Addendum No. 2
October 23, 2025

Project: Beresford High School Addition
Beresford, South Dakota
Project #2979

Architect: Architecture Incorporated

3 PLAN DETAIL - AREA B
4.41 SCALE: 1 1/2" = 1'-0"

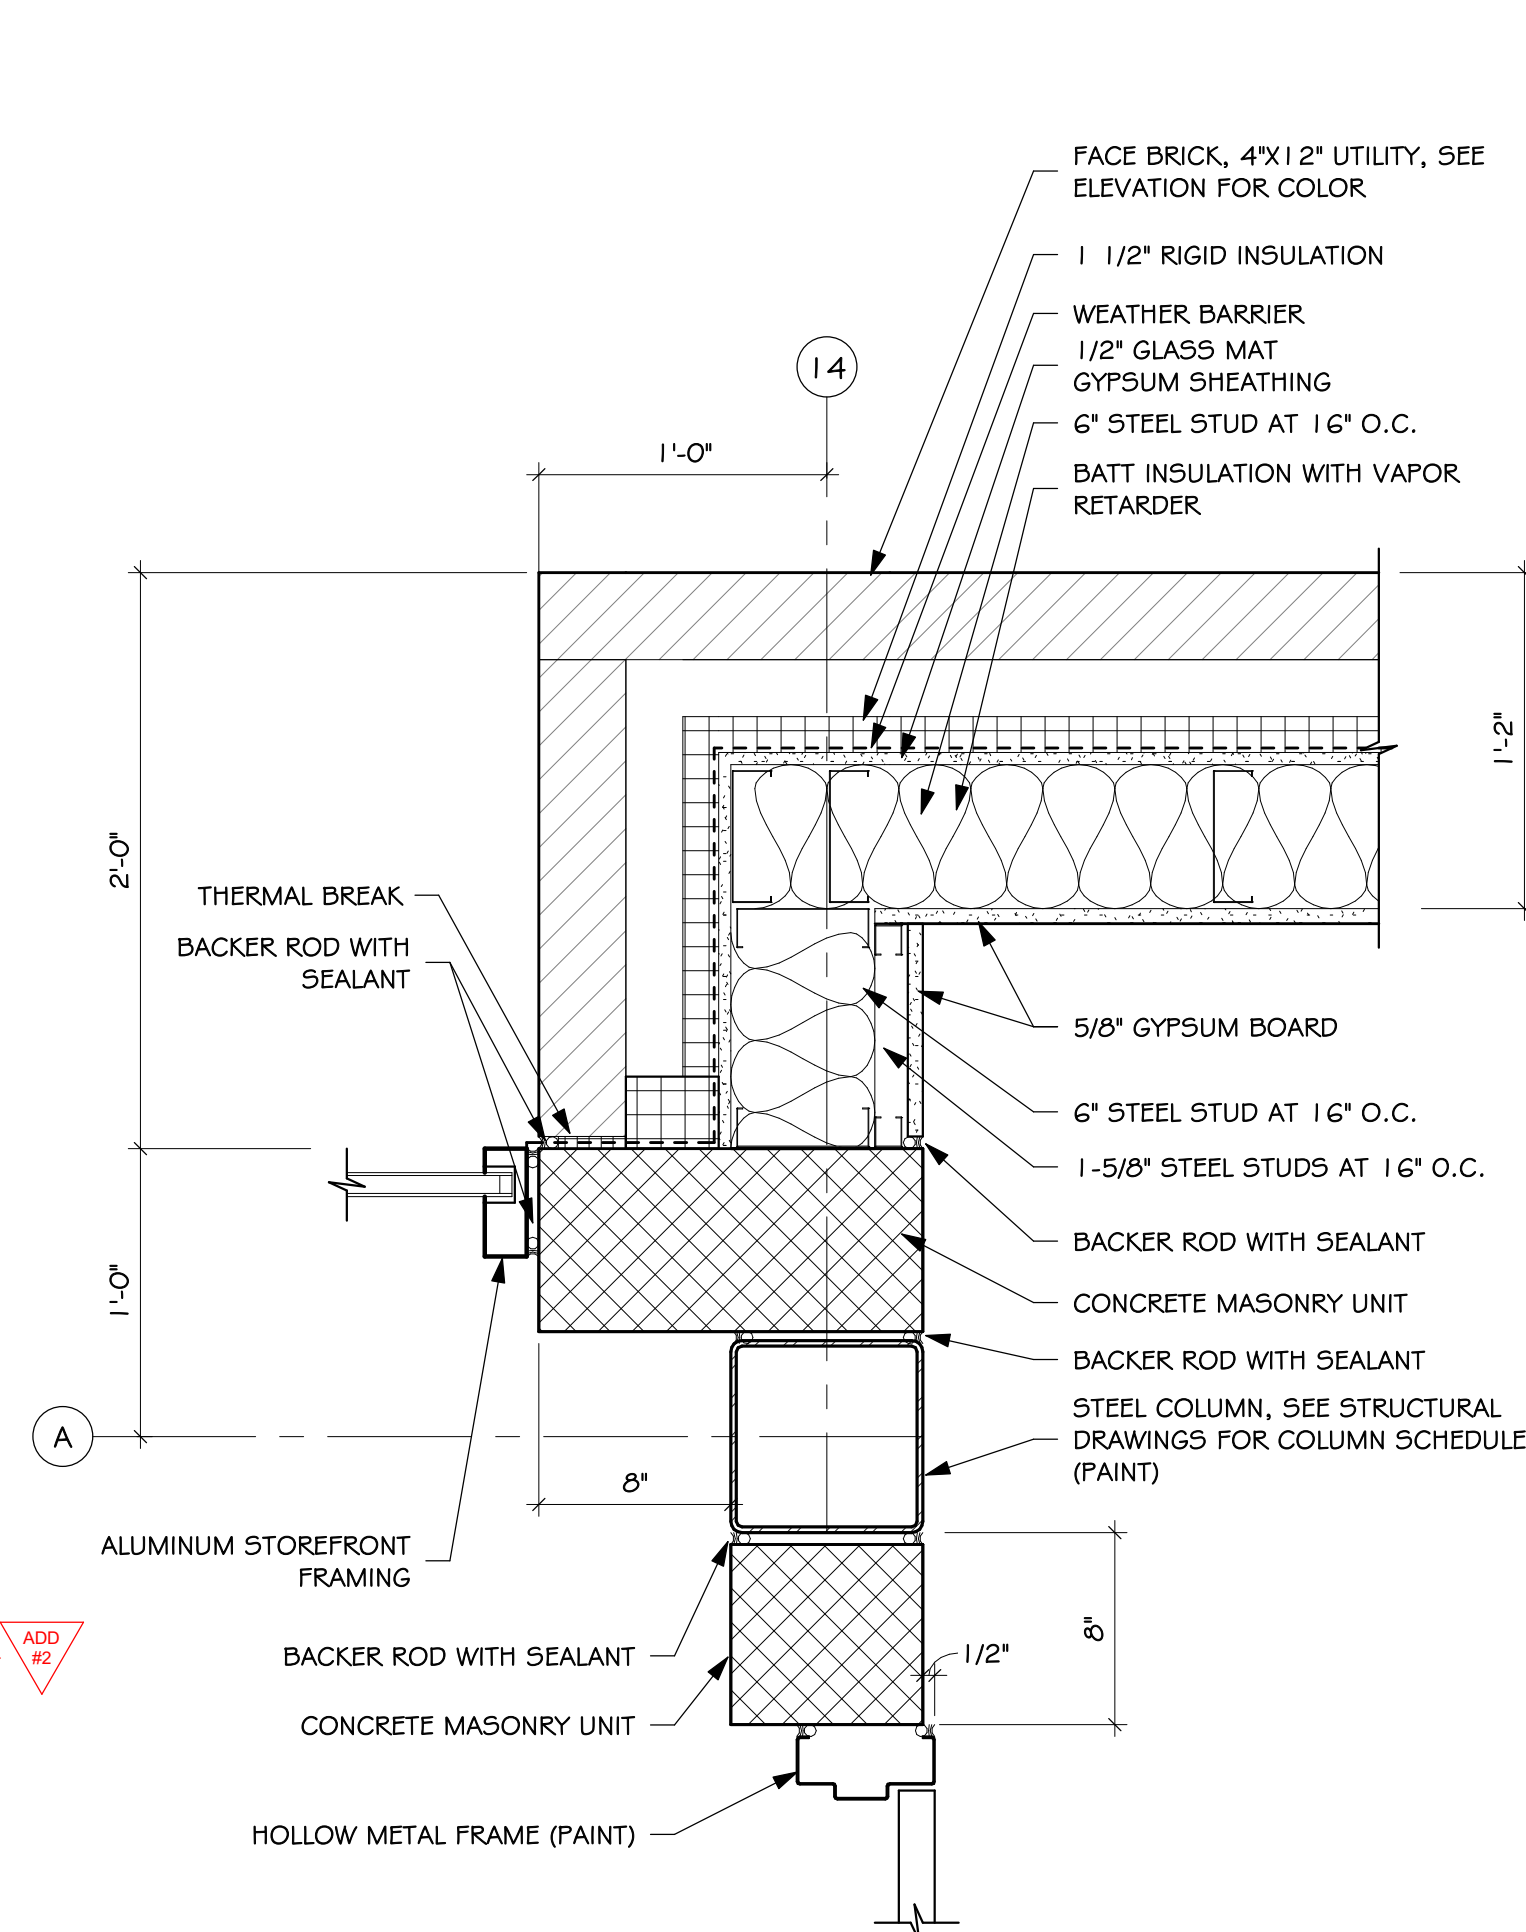
- a) Remove existing CMU wall, insulation and brick as necessary in order to install new footings for new steel columns at grid locations, F4, H4, F10 and H10; see structural drawings Sheet 3.20A and Sheet 3.20B.
 - i) Reference *revised* details 9 & 10 on *revised* Sheet 4.40 and *revised* details 2 & 3 on *revised* Sheet 4.41 – as noted elsewhere in this addendum.

4 DETAIL
5.40 SCALE: 1 1/2" = 1'-0"

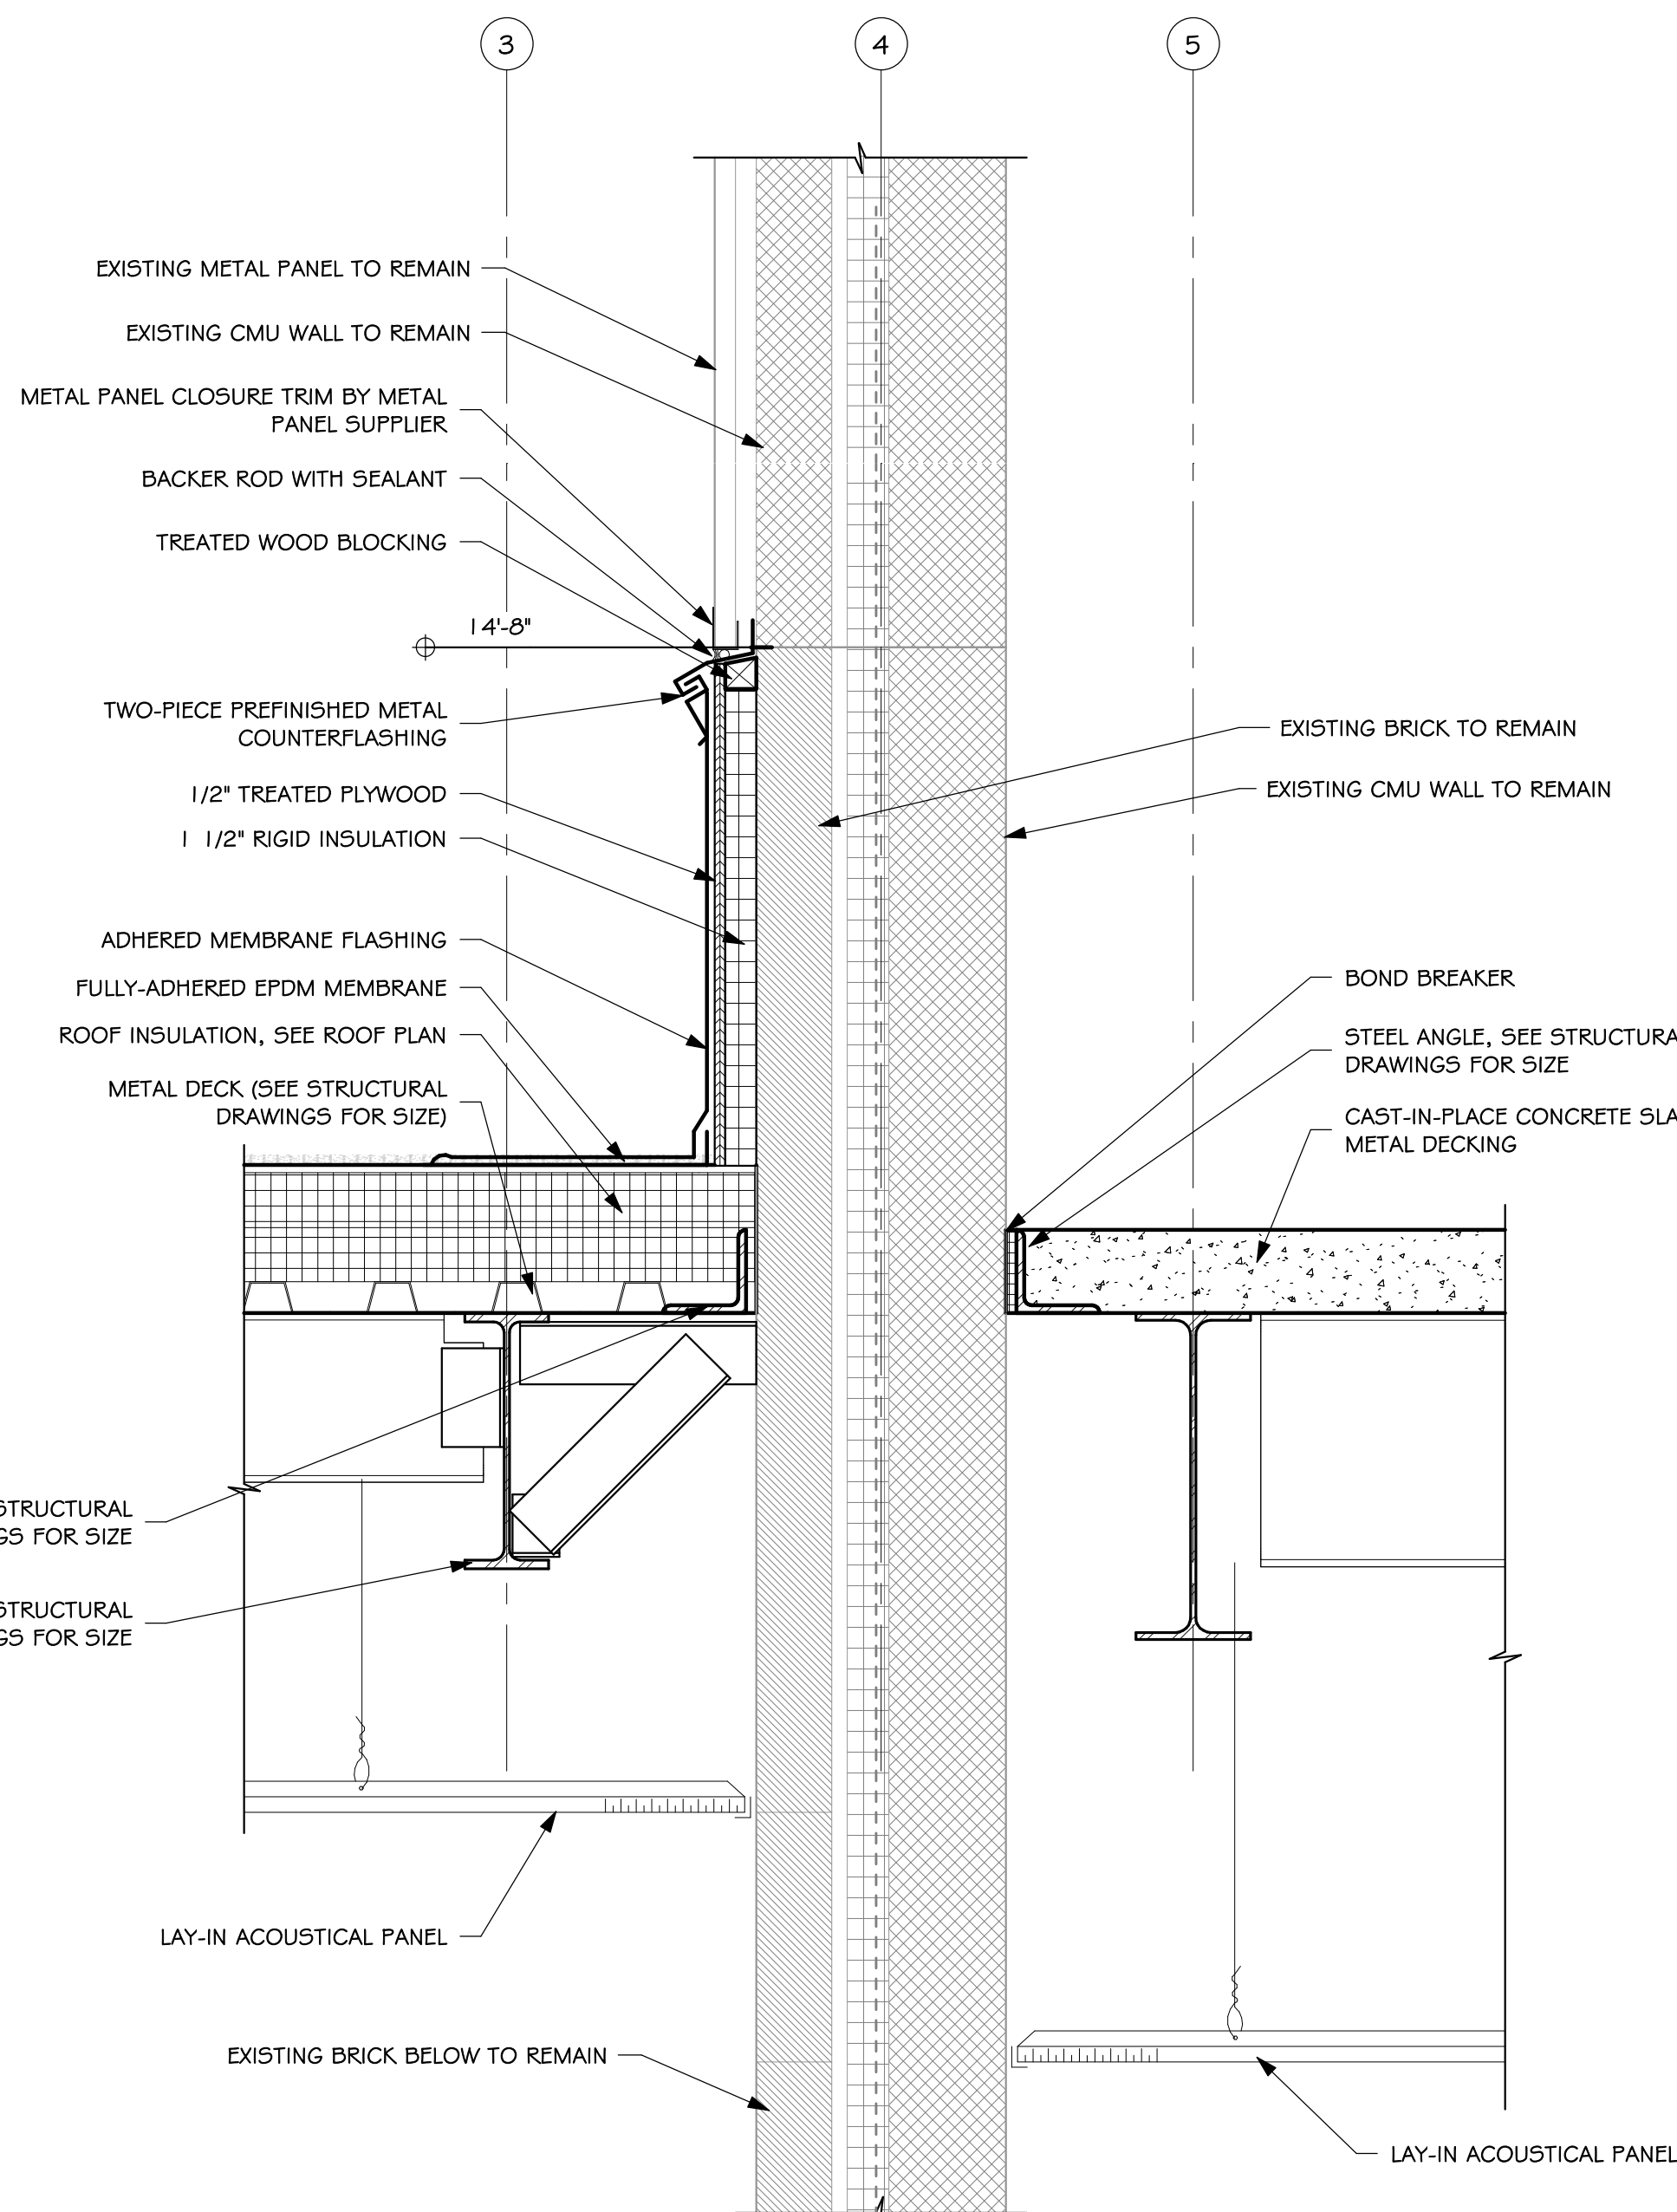
- a) Refer to *revised* detail 4/5.40, *revision* dated 10-23-2025, attached to the end of this addendum for clarification of roof joist pocket on the east wall of the gymnasium. Provide roof joist pockets in the precast for installation of all roof joists. Fill pockets with rigid insulation as shown.

ROOF PLAN

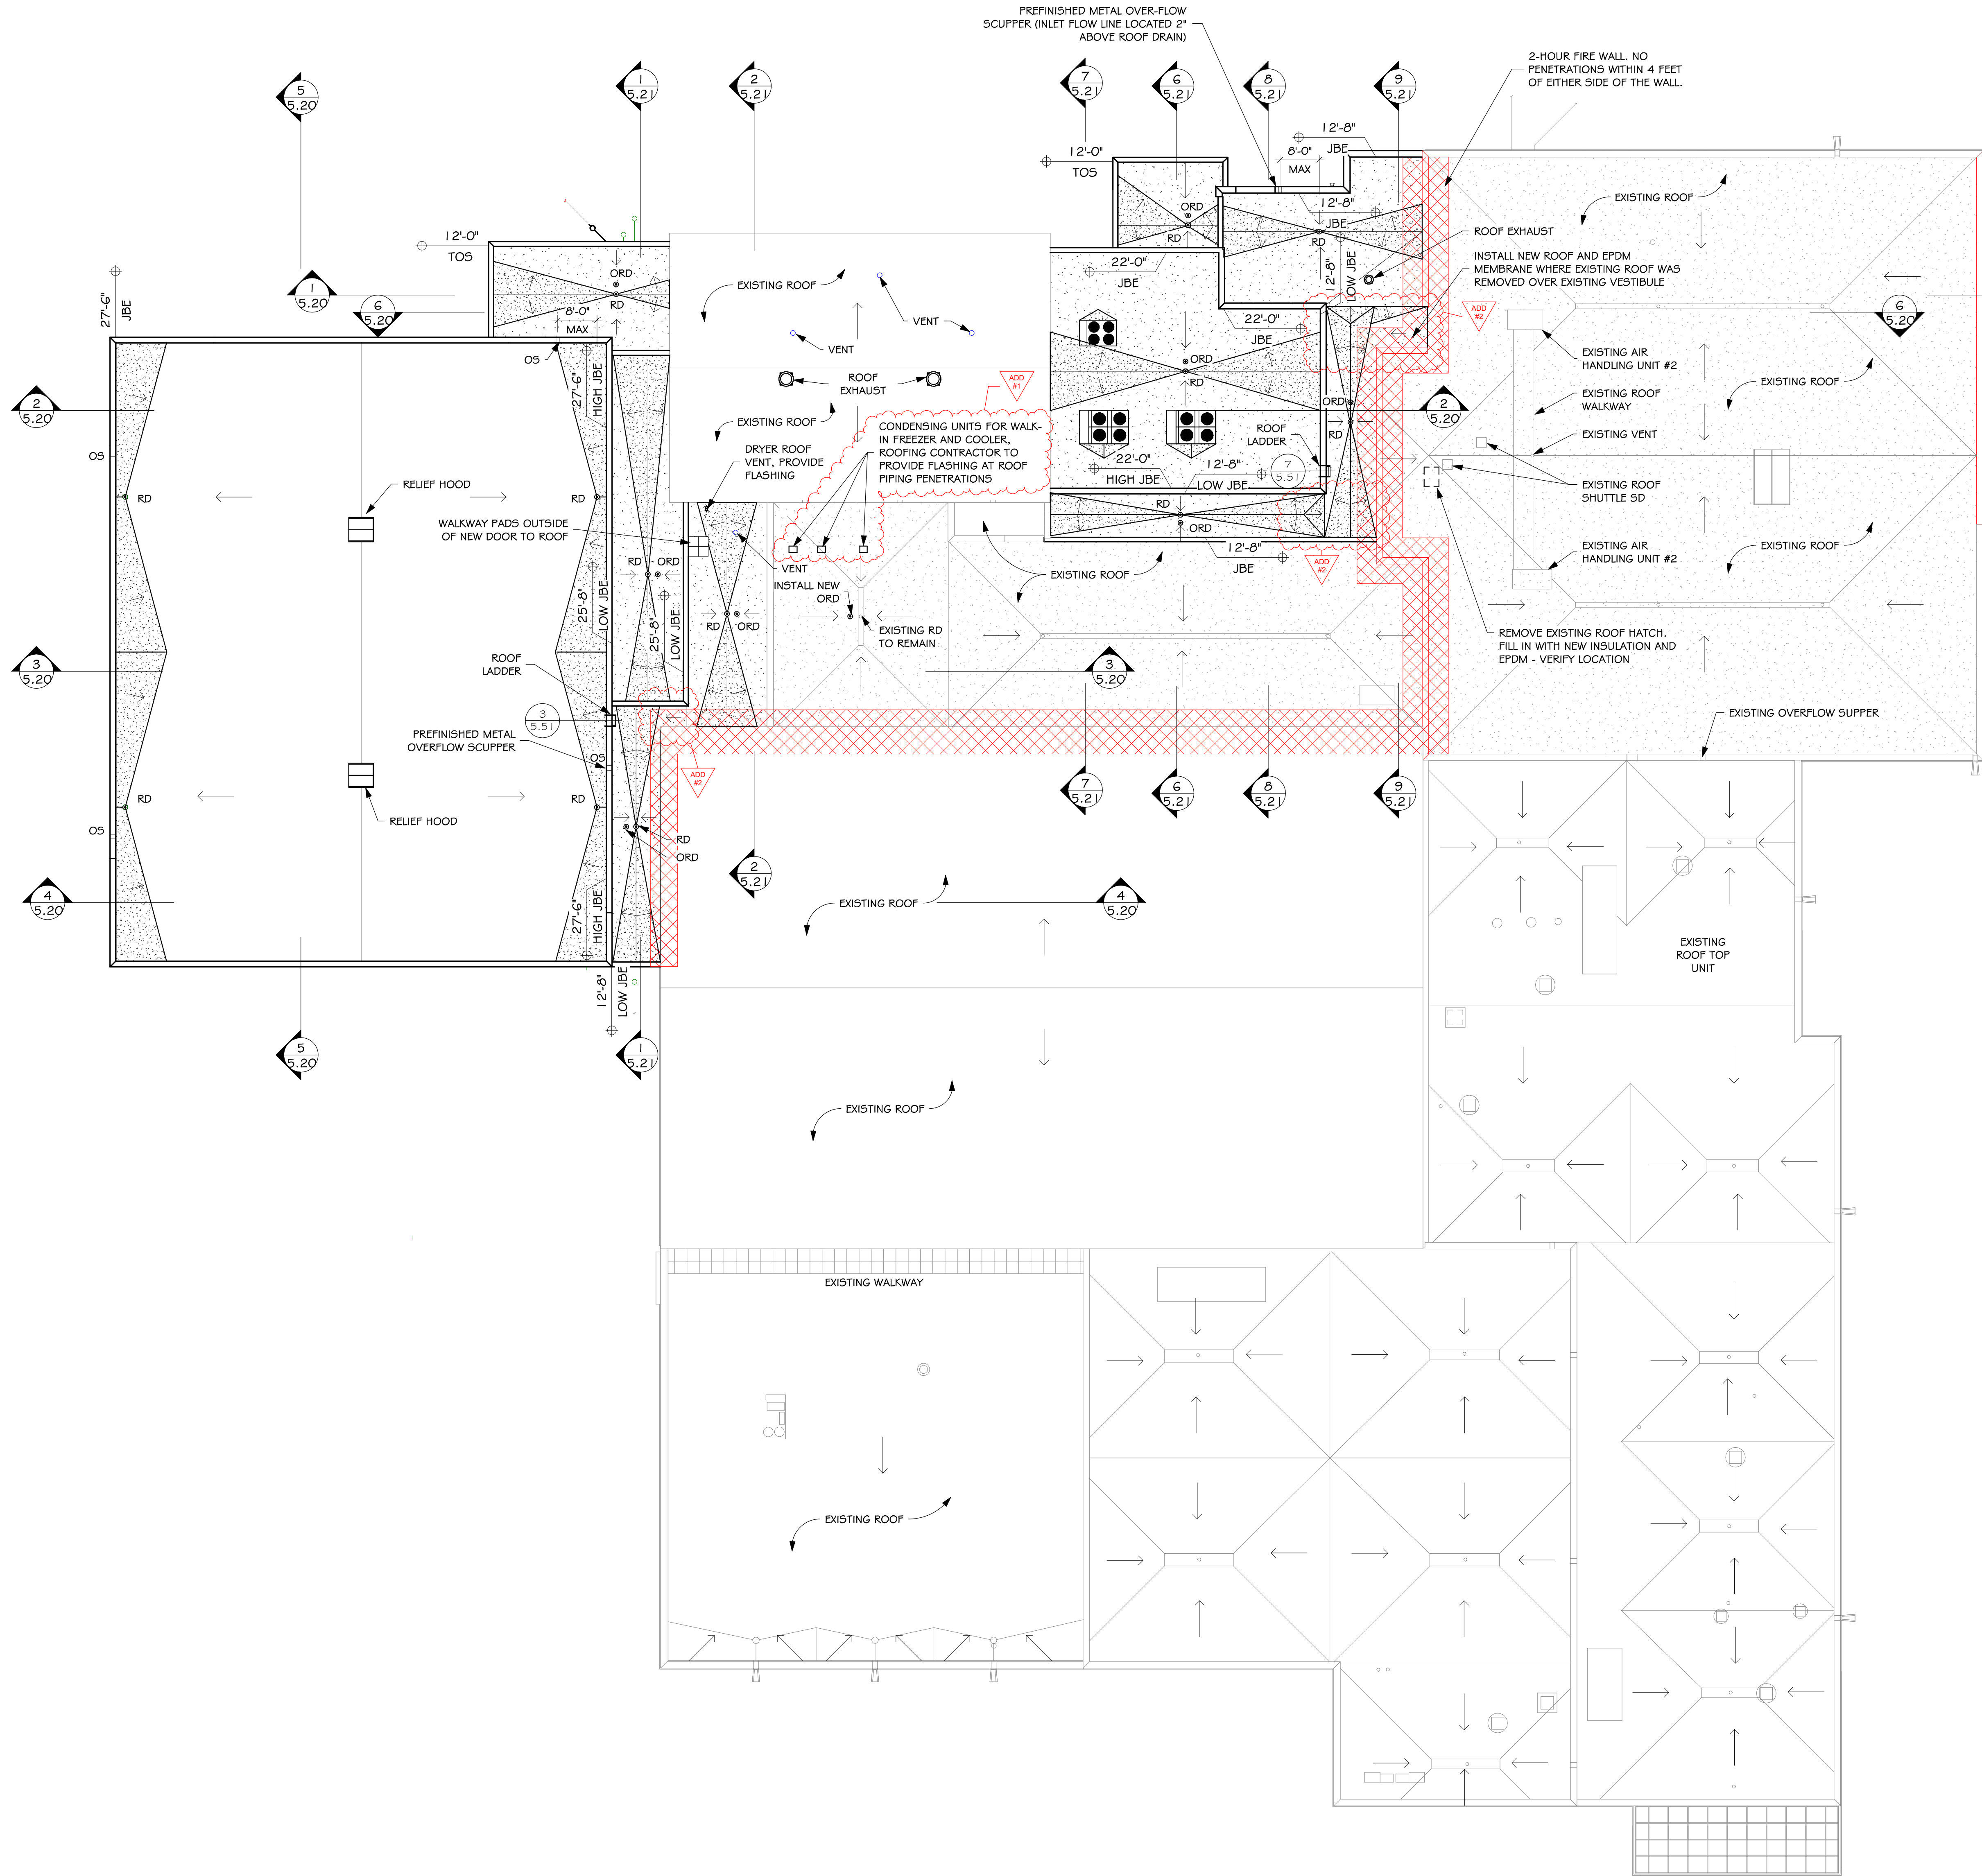
- a) Clarification: Roof Plan Legend is actually a Roof Insulation Legend for all new roofs. All existing roofs as noted on the plan shall remain as is and will not be reroofed. Contractor shall provide membrane flashing at all locations and details as shown on sheet 5.42 where new EPDM membrane connects to existing roof membrane.
- b) Clarification: Omit roof curb notes shown originally on the roof plan.
- c) Refer to *revised* Sheet 5.50, *revision* dated 10-23-2025, attached to the end of this addendum for adjusted roof crickets.
